SITE SUPPLEMENTAL INSTRUCTION

PROJECT: Forestside Estates
Attmar & Palleschi Drive
Brampton, ON

SITE SI NO. M-1

PURPOSE: To revise mechanical layout to suit architectural CS drawing and City comments for P1 level.

TITLE
BLOCK 'D'
4TH FLOOR - PLUMBING/SANITARY

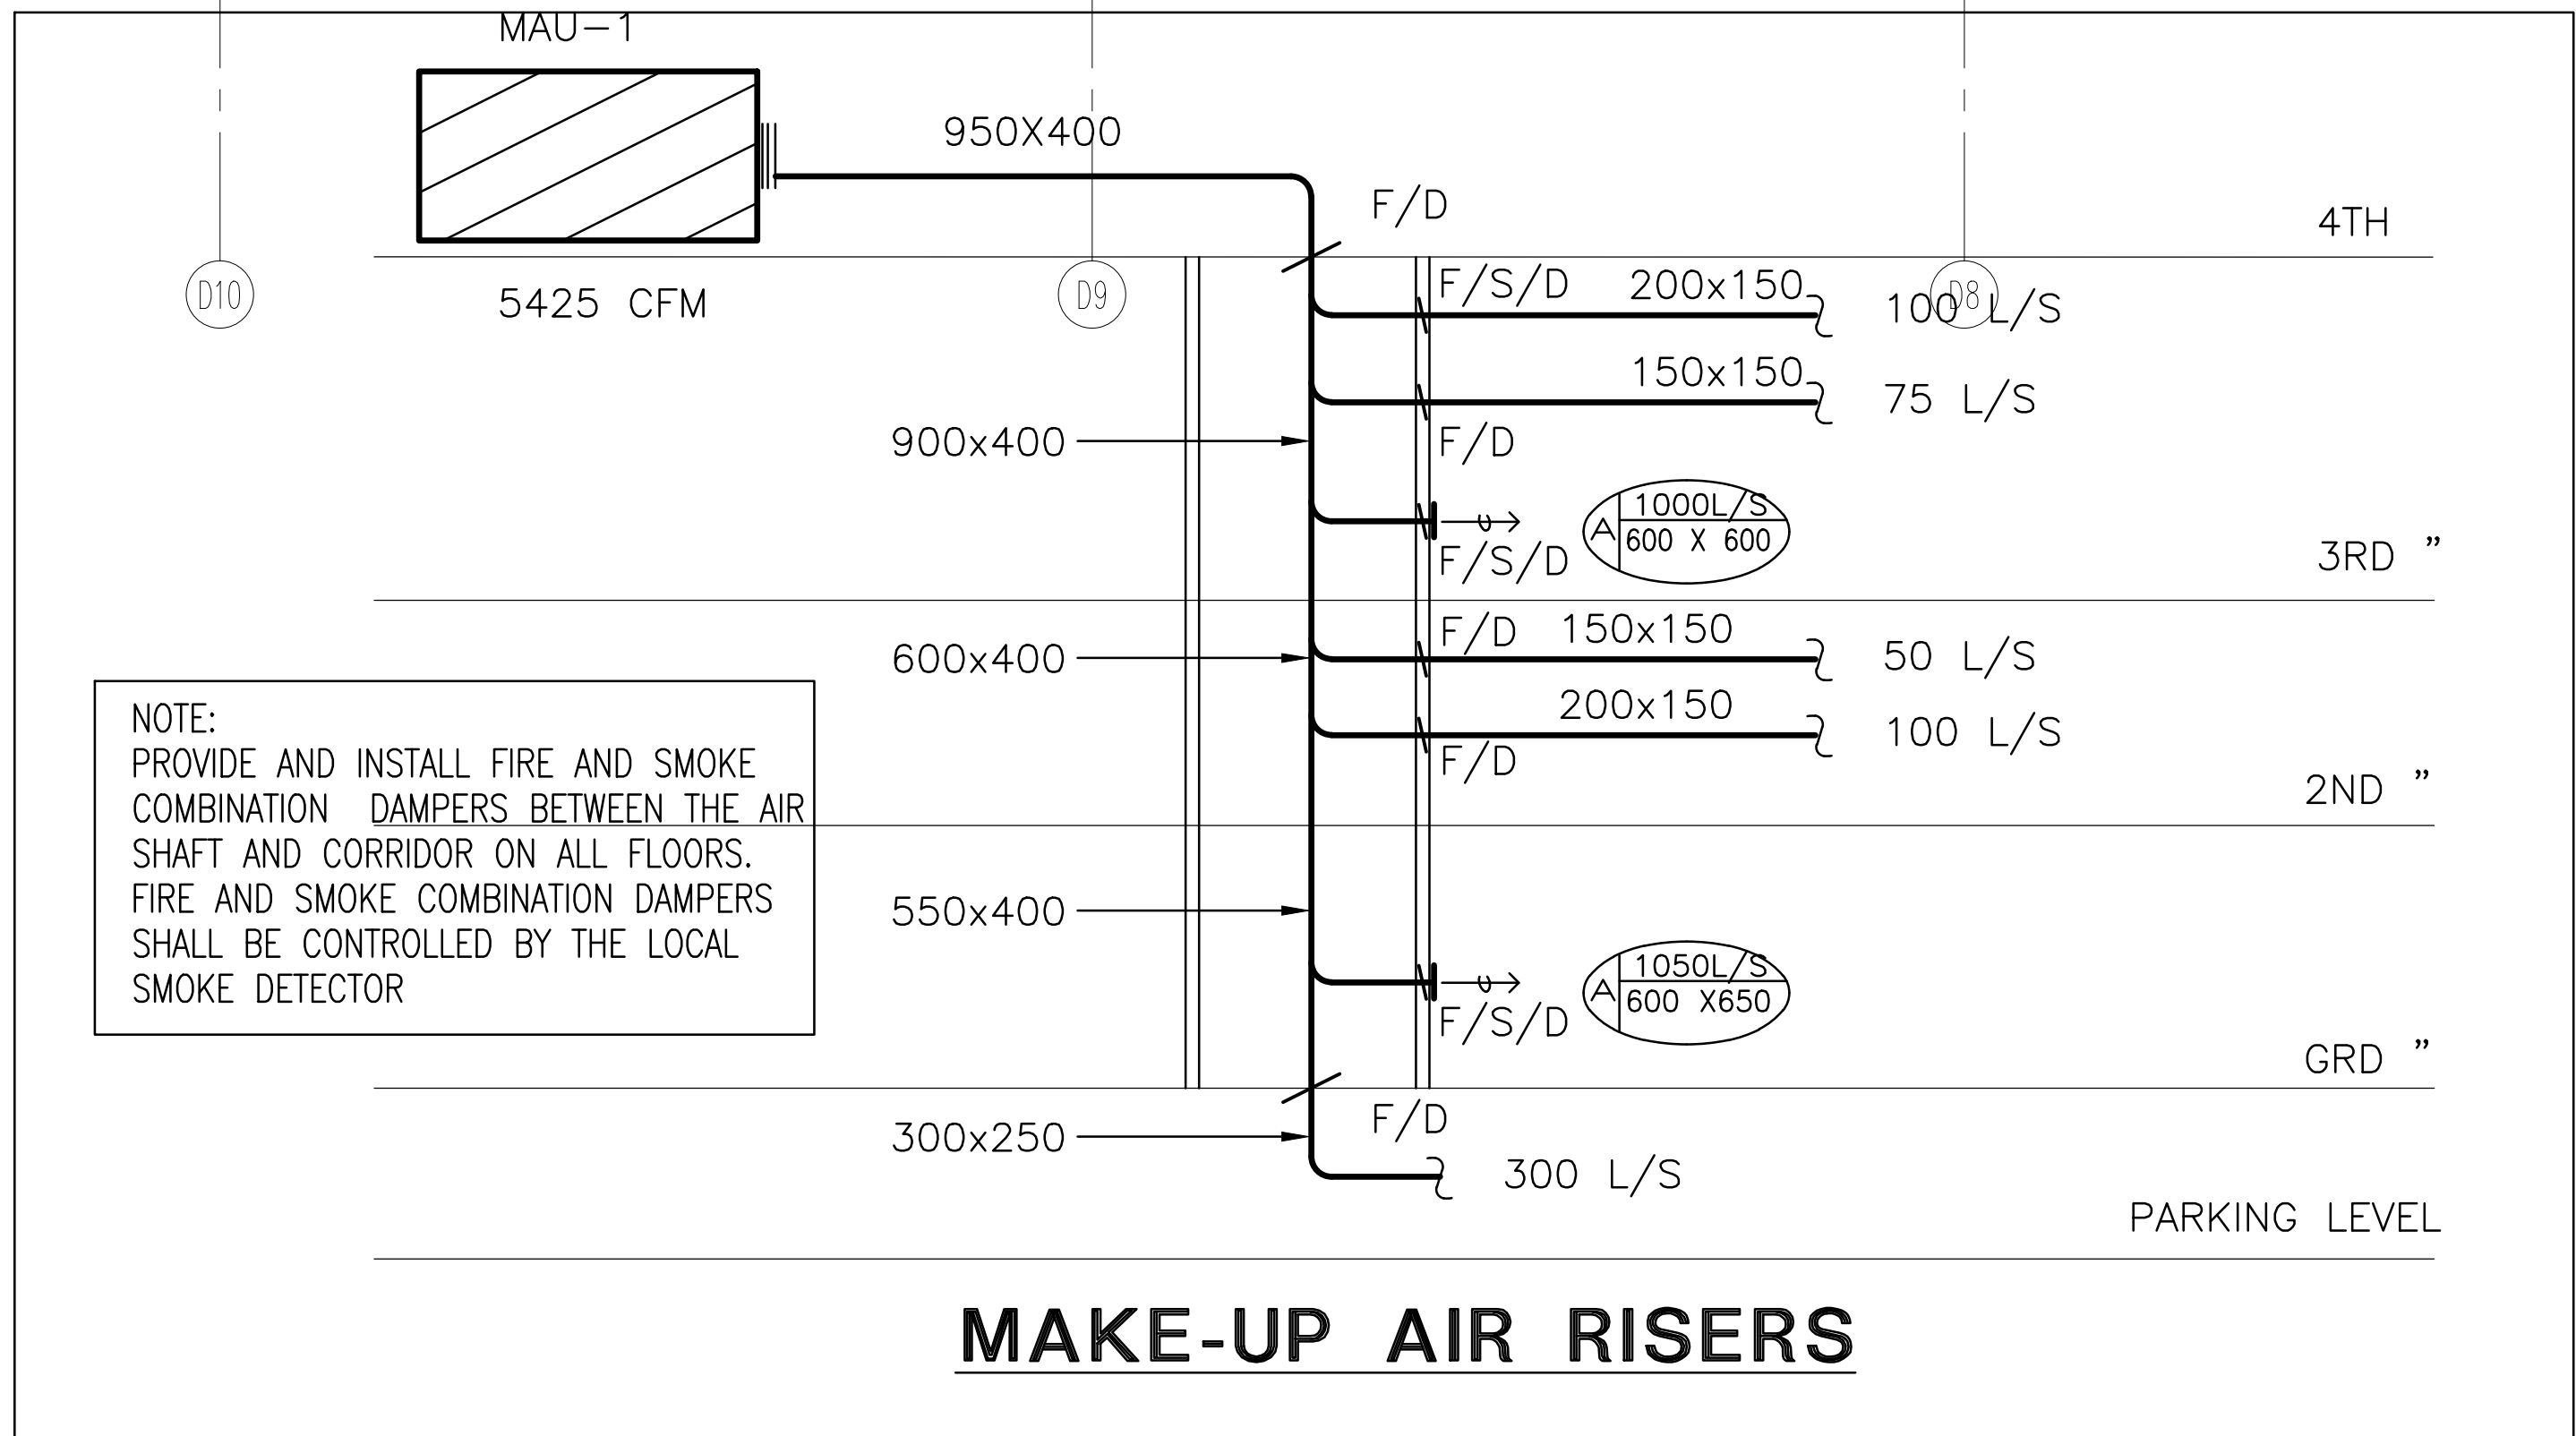
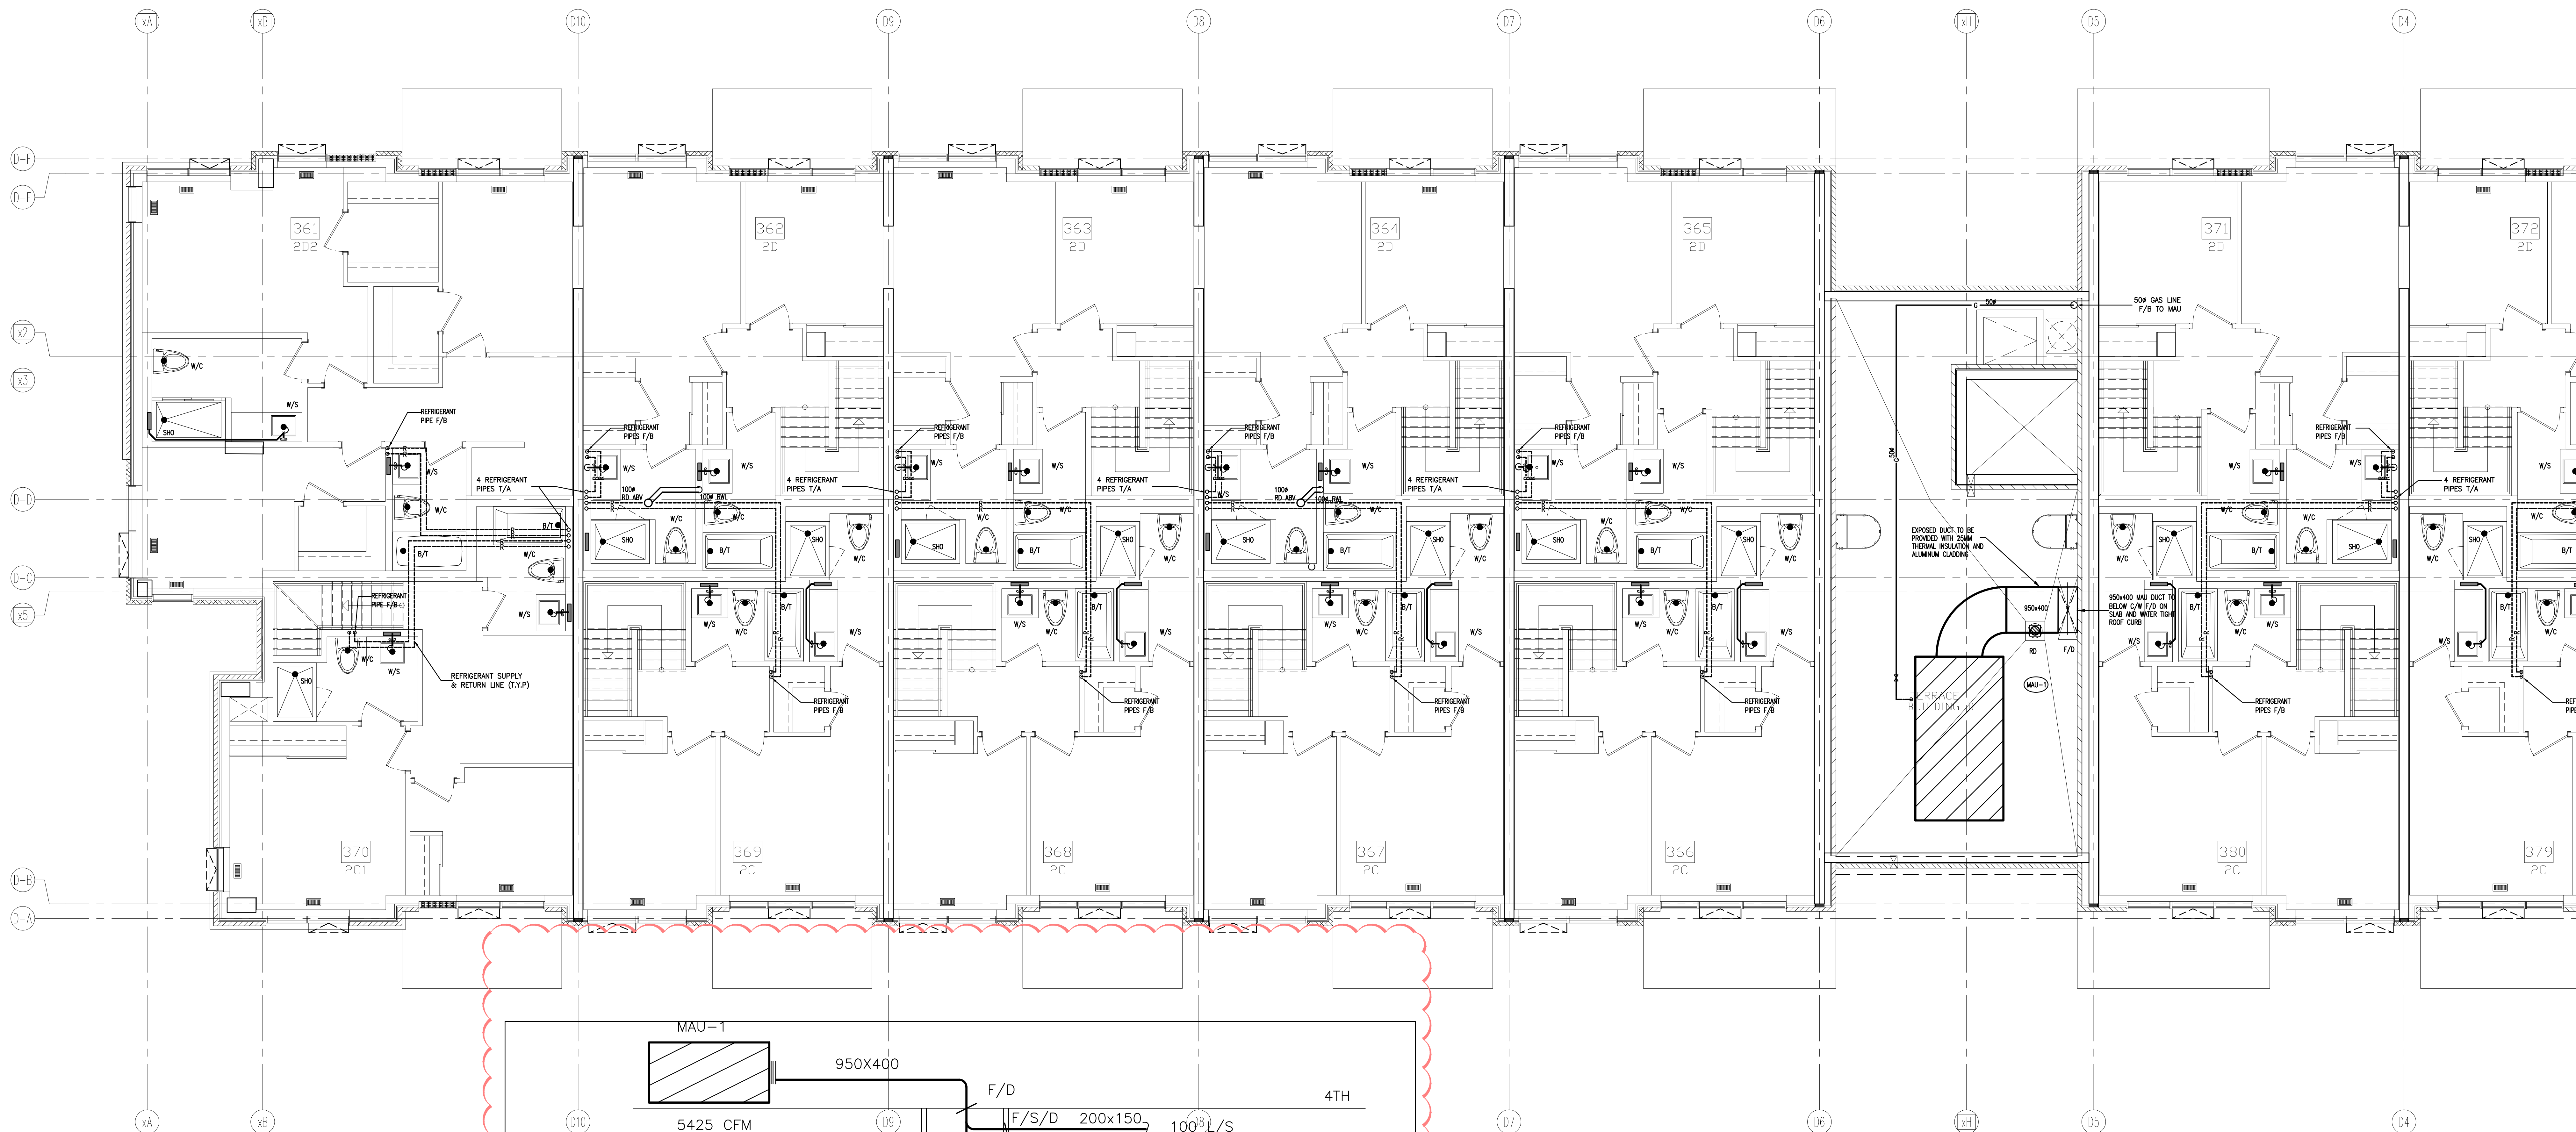
5.0 Reference Drawing M-11 (Blk “D” 4th1 - Mechanical) Issued

5.1 Revise: Mechanical make-up air riser.

5.2 Added: Combined fire and smoke damper for all the opening to public corridor.
